HOSHIZAKI AMERICA, INC.

SERVICE BULLETIN

SB01-0010R

**Subject: Gear Motor Kits For F-800M, F-1000M_B, M_E & M_F
DCM-450/451/500**

3 WIRE APPLICATION

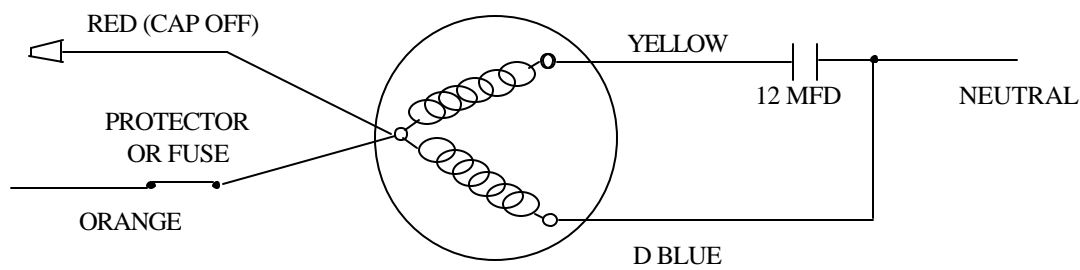
4. The capacitor for the gear motor assembly will be installed in the control box. The wiring of the new capacitor will be the same as the original capacitor.
5. When replacing a three-wire motor, the orange, yellow, and blue wires will be used. The red should be capped off. When replacing a four-wire motor all four wires will be used.
